final environmental impact report
san bruno transit corridors plan

PREPARED BY: CITY OF SAN BRUNO

2.2 RESPONSES TO APRIL 17, 2012 PLANNING COMMISSION MEETING COMMENTS ON THE DRAFT EIR

Figure 11.2

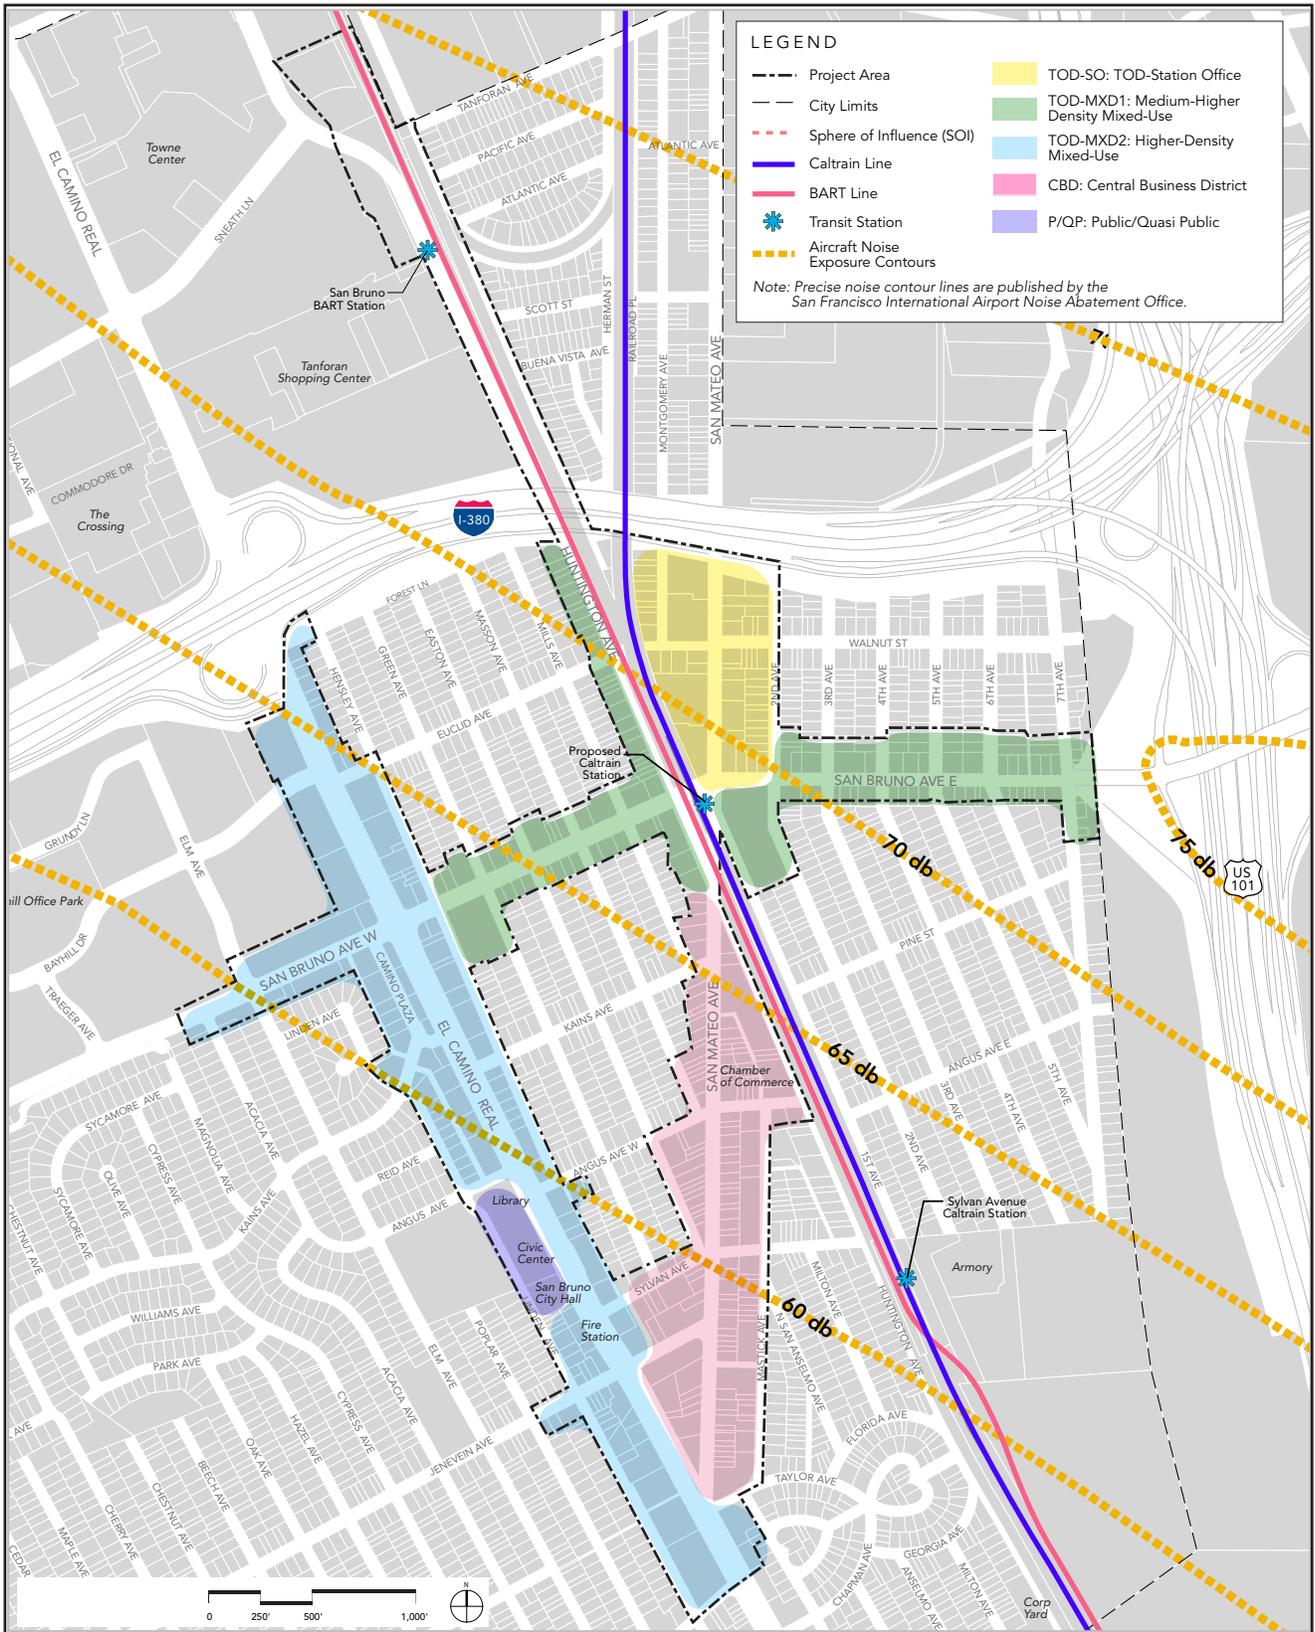
Comment L 2.02: The Transit Corridors Plan would allow new residential development within the San Francisco International Airport 65 decibel (dB) Community Noise Equivalent Level (CNEL) contour; new residential development is not an appropriate land use within the airport's 65 dB CNEL contour. However, should residential development be approved within the 65 dB CNEL contour, all units should be constructed to ensure an interior CNEL due to aircraft noise of 45 dB or less in all habitable rooms, and each unit must grant to the airport an aviation easement for aircraft noise.

Mitigation 11-5 has been revised to clarify that units should be constructed to ensure an interior CNEL due to aircraft noise of 45 dB or less in all habitable rooms, and each unit must grant to the airport an aviation easement for aircraft noise.

In addition, a new figure has been added to the Draft EIR to depict the relationship between airport noise levels and land uses within the Plan area. Figure 11-2 shows aircraft noise exposure contours overlaying the Plan area.
